Access Compliance Report Public Rights-of-Way (Curb Ramps)

Main Street: DAWNWOOD Cross Street: CALM_CREEK_CIR Location: NW

ADA ID: RPRK211025115404 Ramp Type: Type 4 - Parallel Initial Pass/Fail: Pass Overall Compliance: No Severity Score: 25

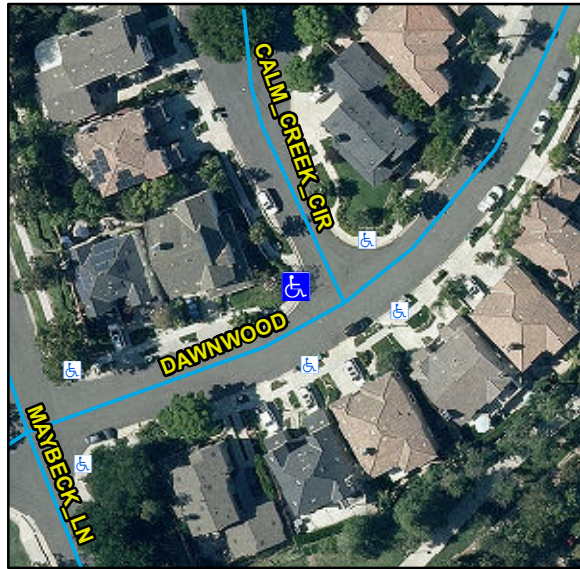
Compliance	Description	Data	Compliance	Description	Data
N/A	Ramp Length LT (in)	109	N/A	Ramp Length RT (in)	110
Yes	Ramp Width LT (in)	53	Yes	Ramp Width RT (in)	53
Yes	Ramp Run Slope LT (%)	4.4	Yes	Ramp Run Slope RT (%)	5.2
Yes	Ramp Cross Slope LT (%)	1.2	Yes	Ramp Cross Slope RT (%)	1
N/A	Landing Present	No	No	DWS Provided	No
N/A	Landing Length (in)	N/A	N/A	DWS Contrast	N/A
No	Landing Width (in)	N/A	N/A	DWS Length (in)	N/A
No	Landing Run Slope (%)	N/A	N/A	DWS Full Width	N/A
No	Landing Cross Slope (%)	N/A		DWS Offset Type	N/A
N/A	Landing Movement Obstructed?	No	N/A	DWS Offset Left (in)	N/A
	Landing Movement Type	Curb	N/A	DWS Offset Right (in)	N/A
N/A	Landing Shared	N/A			
N/A	Clear Space	Yes			
N/A	Clear Space To Crosswalk (in)	48			
N/A	Marked Crosswalk 1	No	N/A	Marked Crosswalk 2	No
	Crossing 1 Direction	S		Crossing 2 Direction	E
	Marked Crosswalk 1 Width (in)	N/A		Marked Crosswalk 2 Width (in)	N/A
N/A	Ramp Inside Crosswalk 1	N/A	N/A	Ramp Inside Crosswalk 2	N/A

Crossing 1 Slope (%)	2.8		Crossing 2 Slope (%)	1
	Crossing 1 Cross Slope (%)	1.2		Crossing 2 Cross Slope (%)	2.3
Yes	Gutter Ponding	No	Yes	Curb Slope	7.4
Yes	Gutter Lip Height (in)	0		Road Run Slope (%)	0.4
No	Gutter Run Slope (%)	9		Road Cross Slope (%)	2.3
Yes	Gutter Cross Slope (%)	0.2	No	Perpendicular Joint Present	No
Yes	Overall Surface Condition	Acceptable			
	Cross Gutter Present?	No		Spandrel Present?	No
	Replace Cross Gutter?	N/A		Replace Spandrel?	N/A

Remove & Replace Curb Ramp With Two New Directional Ramps or Equivalent. Remove & Replace Gutter.
